REMARKS/ARGUMENTS

Reply to Office Action dated December 15, 2009

Fig. 2

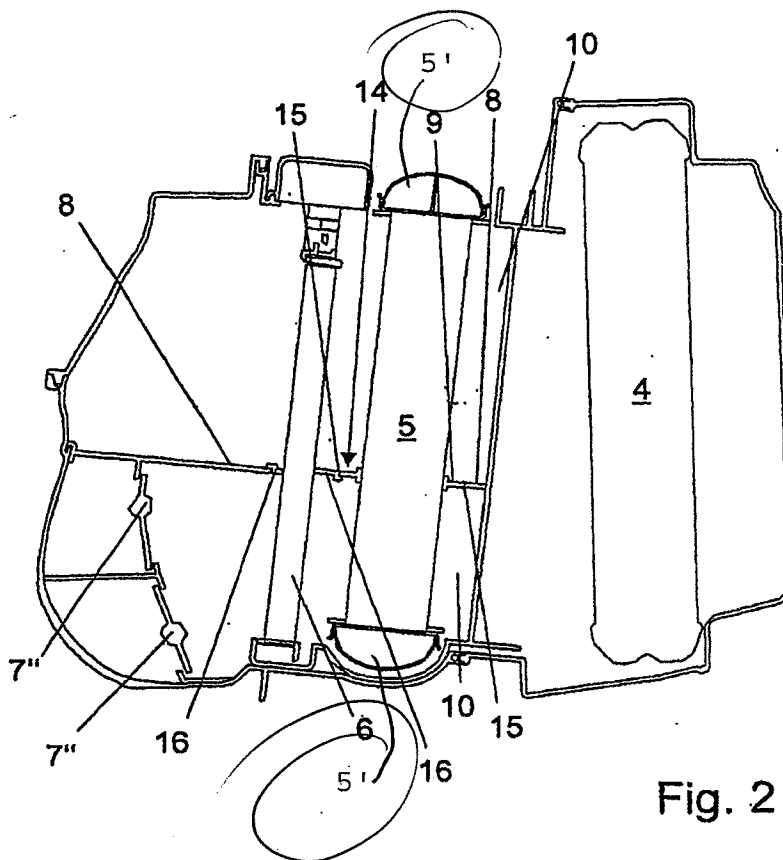
Finally, the Office Action indicates that the meaning "network of the heat exchanger" is not clear and that "collecting tanks" are not illustrated. It is respectfully submitted that one of ordinary skill in the art would recognize the generally hemispherical elements on the top and bottom of heater 5 in Figure 2 as "collecting tanks" for water flowing through heater 5 which comprises a fluid-filled heat exchanger. A replacement drawing sheet is submitted herewith which includes reference numerals 5' to identify the collecting tanks, which are mentioned at page 5, line 12, of the

application. The "network" of the heat exchanger comprises the flat tubes or pipes and associated cooling fins in between the collecting tanks. By the above amendment, claim 7 has been revised to refer to the "central portion" of the heater instead of a "network." Figure 2 shows that the central portion of the heater 5 is undercut with respect to the wider collecting tanks 5', and this arrangement is discussed at page 5, lines 3-16. It is therefore respectfully submitted that the above amendment to claim 7 is supported by the specification and does not constitute new matter. The withdrawal of the claim rejections under 35 U.S.C. 112, second paragraph, is respectfully requested in view of the above amendments and foregoing remarks.
